ZIMMERMAN GARDENS

Greenpark	185 62M-1265 19014
RUSSELL GARDENS PHASE 3	LOT SITING/GRADING
DATE: 2020 DRAWN BY: [Signature] CHECKED BY: [Signature] SCALE: 1:250 GREG - H:\ARCHIVE\WORKING\2019\19014\GRE SITE PLAN\19014-RG3-SITE-LAYOUTS.dwg - FR - Nov 20, 2020 - 9:56:AM	1 19014-RG3-SITE-LAYOUTS

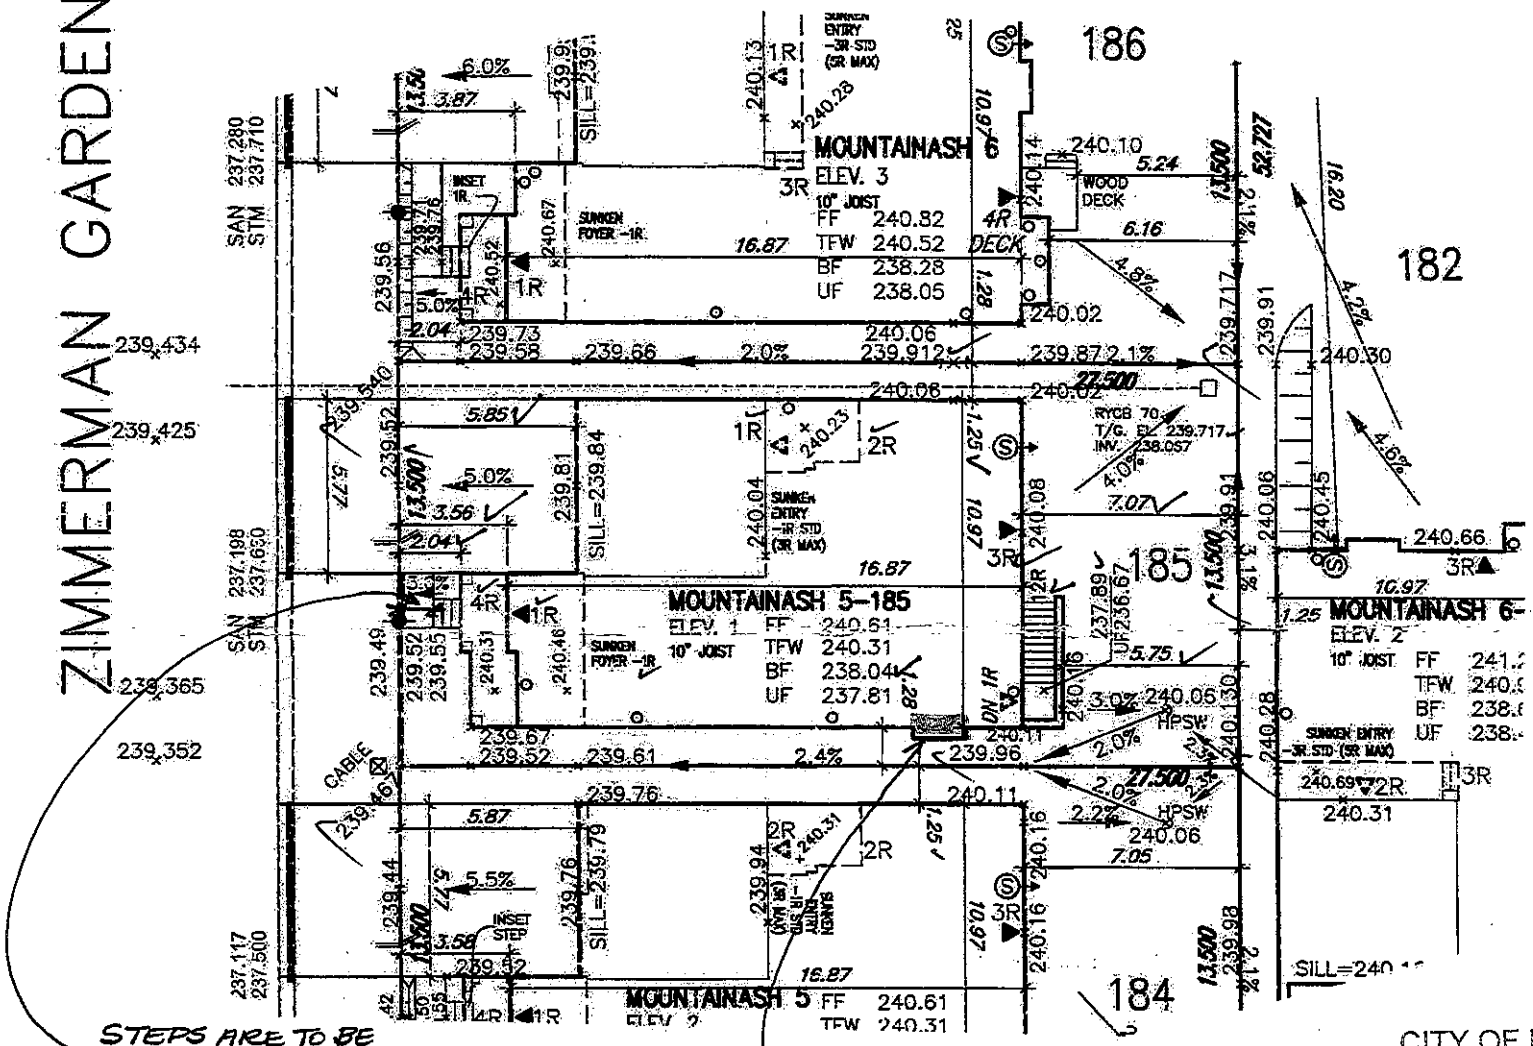
STEPS ARE TO BE MIN. 1m FROM FRONT PROPERTY LINE, THEREFORE, STEPS ARE MAX. 13" EACH (3 STEPS) MAX.

MIN 45 MIN. FRR
NO UNPROTECTED OPENINGS.
